**NSLPP MEETING HELD ON 01/05/24****Attachments:**

ADDRESS/WARD: Unit 9 and 9A, 50 Milson Road, Cremorne Point**APPLICATION NO:** DA353/23**PROPOSAL:** Consolidation of two units, alterations and additions including internal demolition and reconfiguration, landscaping and addition of pergola on existing roof terrace.**PLANS REF:**

OWNER: Robyn Mary Assunta Denholm**APPLICANT:** Robert Furey C/O Walter Barda Design**AUTHOR:** Report of Robin Tse, Senior Assessment Officer**DATE OF REPORT:** 22 April 2024**DATE LODGED:** 15 December 2023**RECOMMENDATION:** Approval

Print Date & Time: 15/12/2023 3:44:22 PM
File Path: Z:\0202_24_Denholm Taylor Penthouse\02 - Architectural Plans\02 DA - Proposed Alterations\13 - Milson Rd Penthouse.rvt
Drawn By: RF
Checked By: WB
Approved By: WBD
Scale @ A1 As indicated
Drawing Number: A201
Issue: E

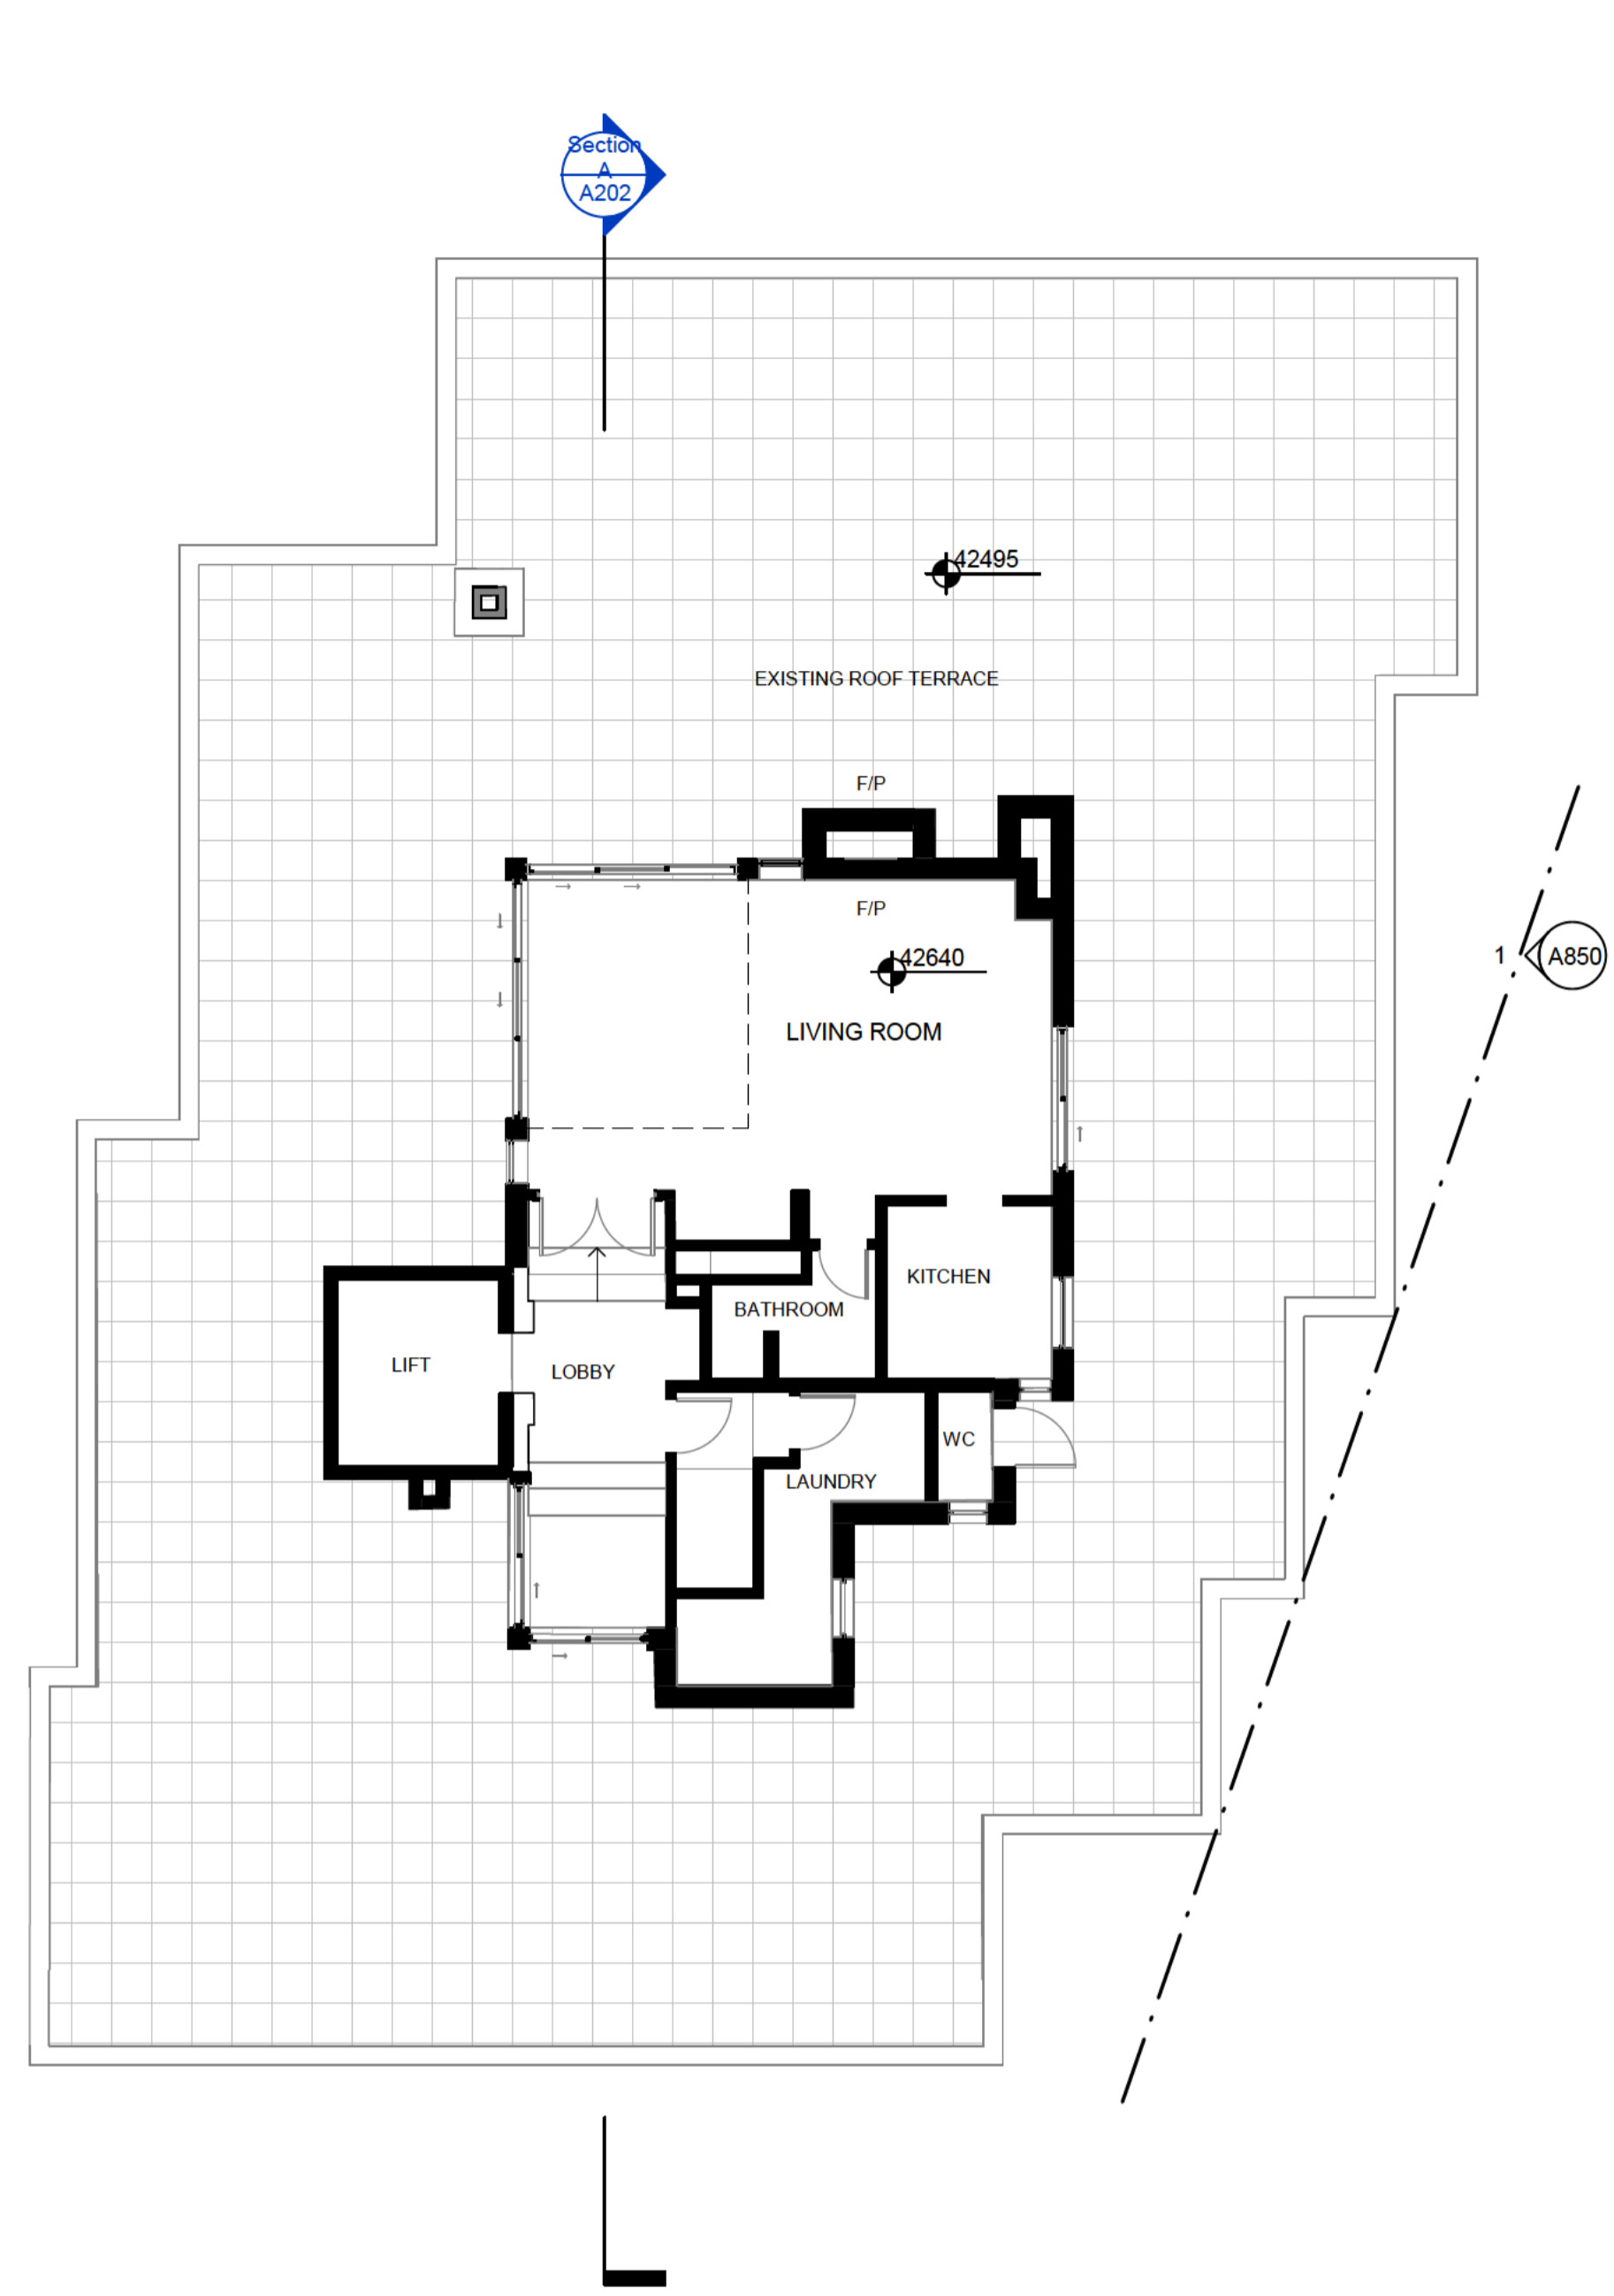
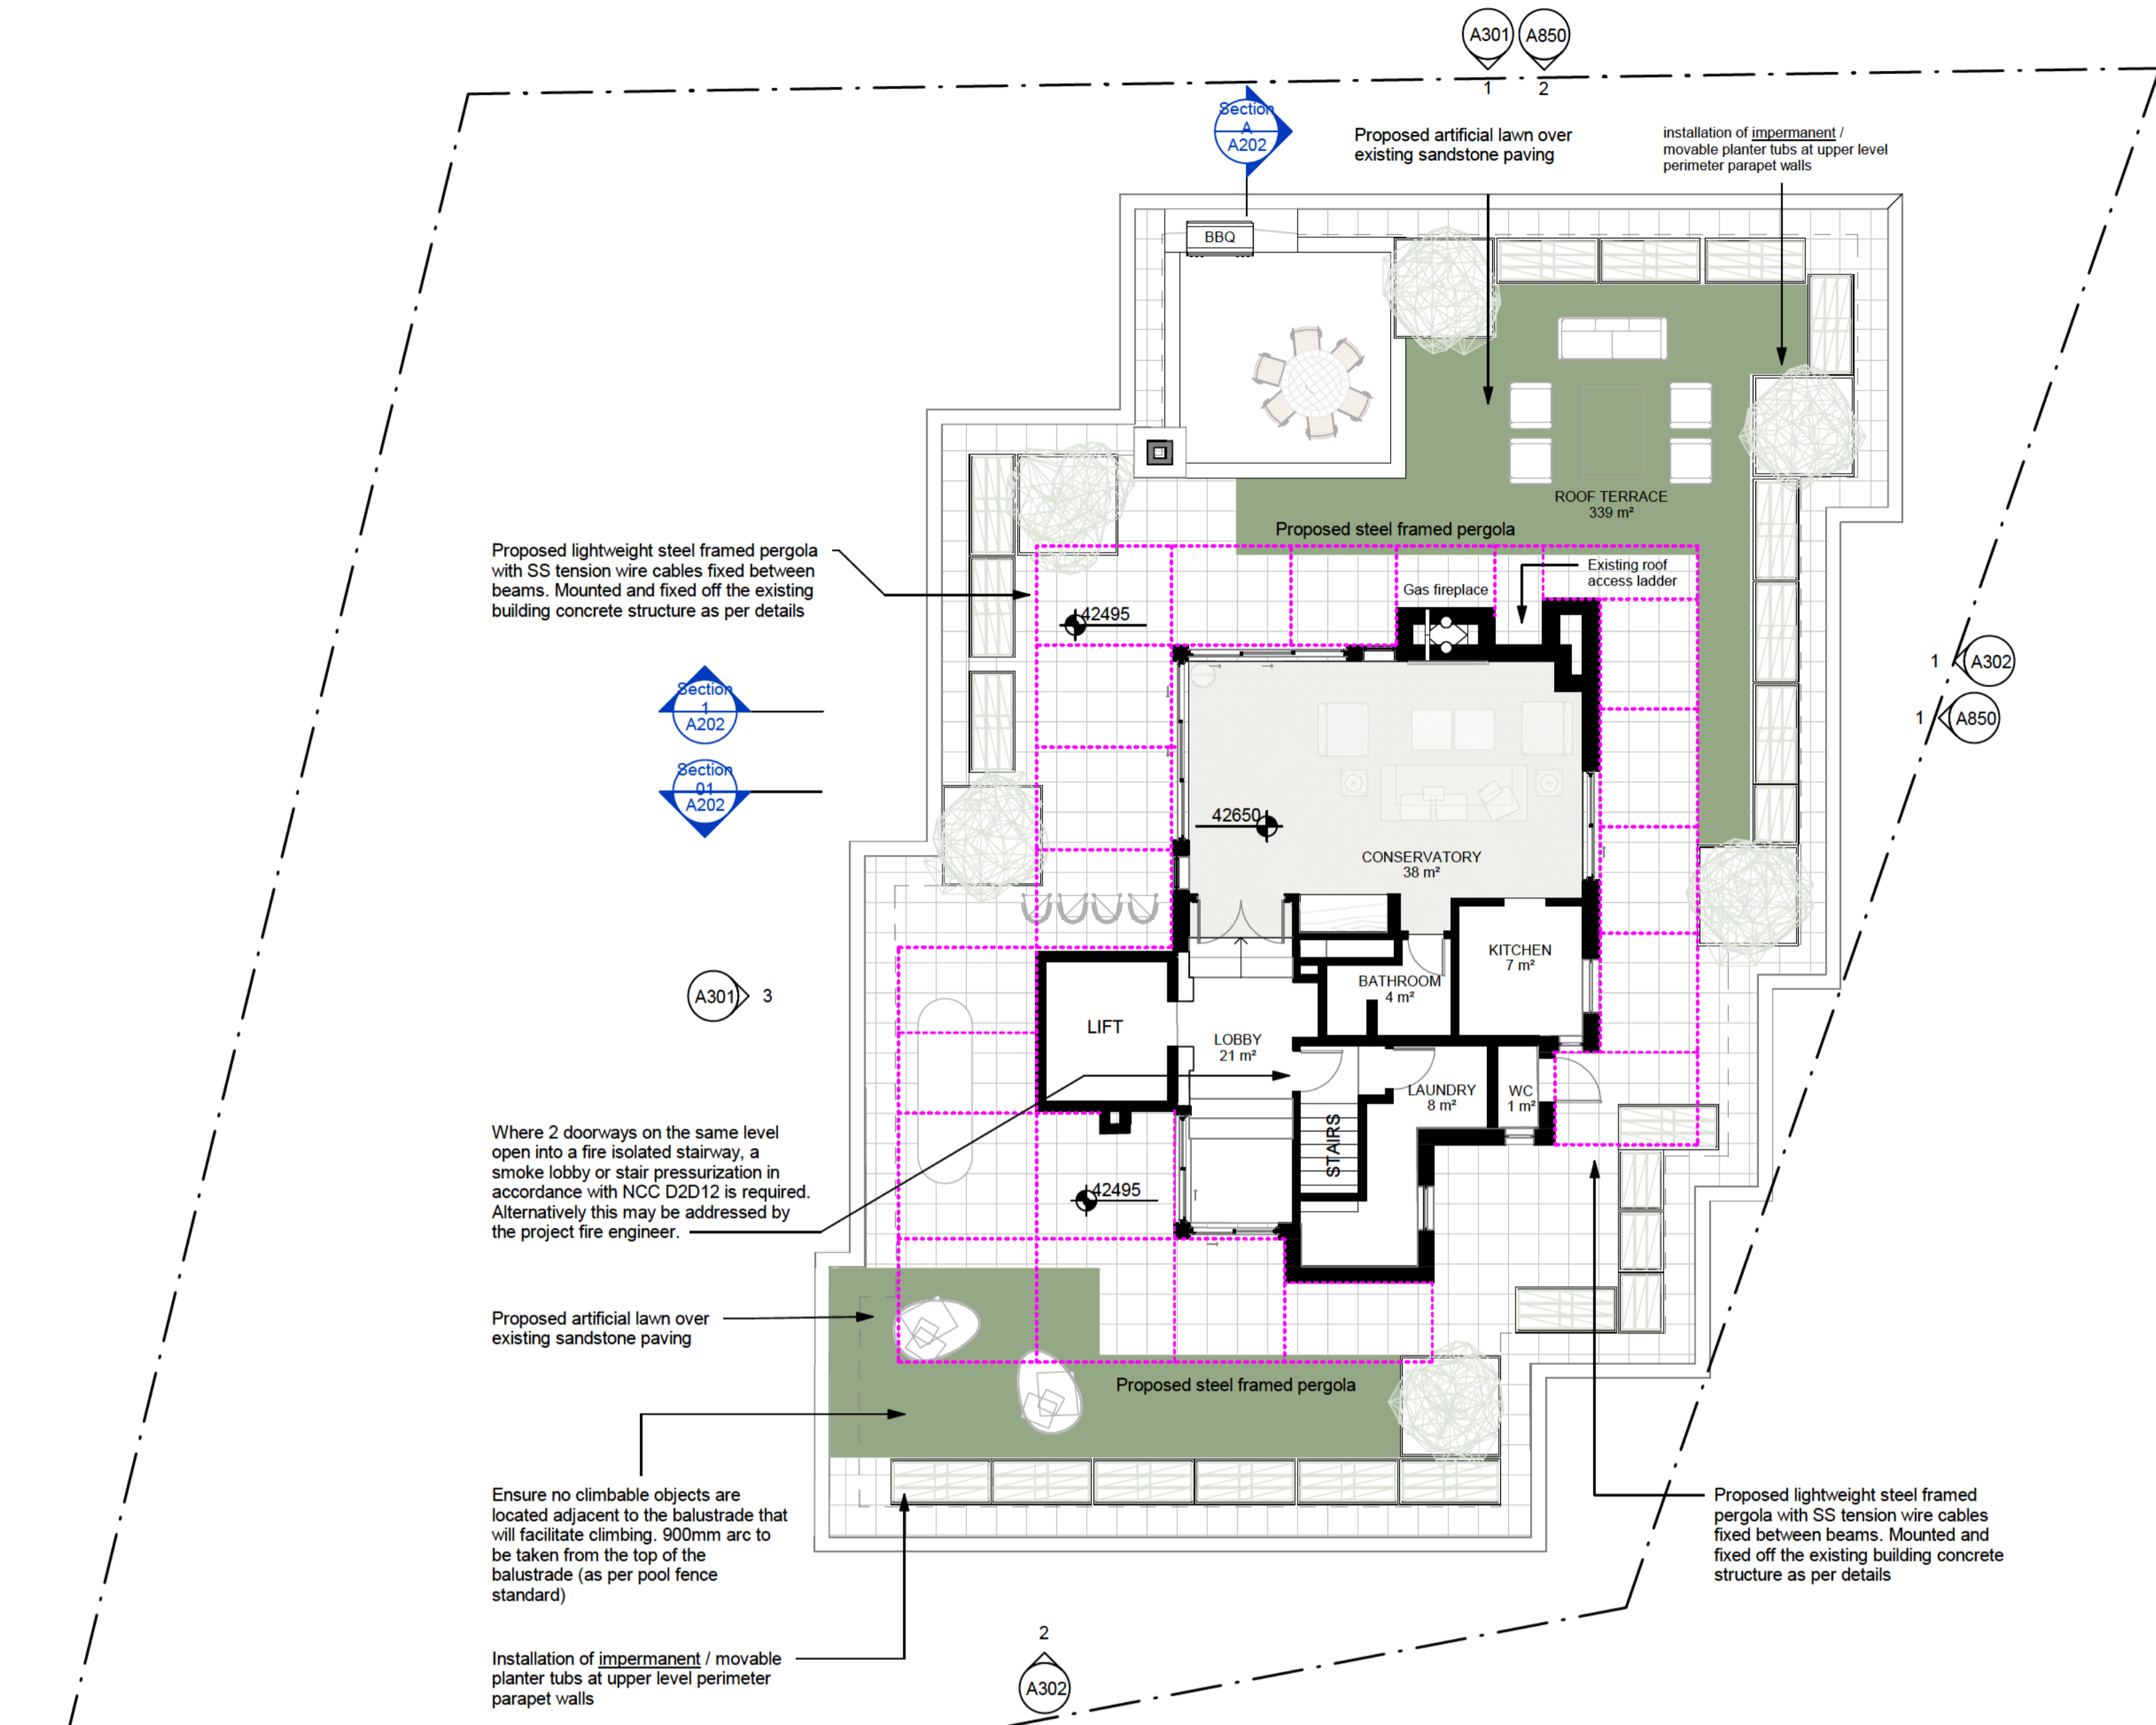
- C1. A landscape plan, based on drawing numbered A201 Issue E and dated 15.12.23, showing the landscape treatments on roof terrace shall be prepared with details on species names, number and pot sizes of all plantings.

The planting on the roof terrace must be maintained to a height not higher than the height of the roof parapet to minimise any impacts on views as seen from neighbouring properties.
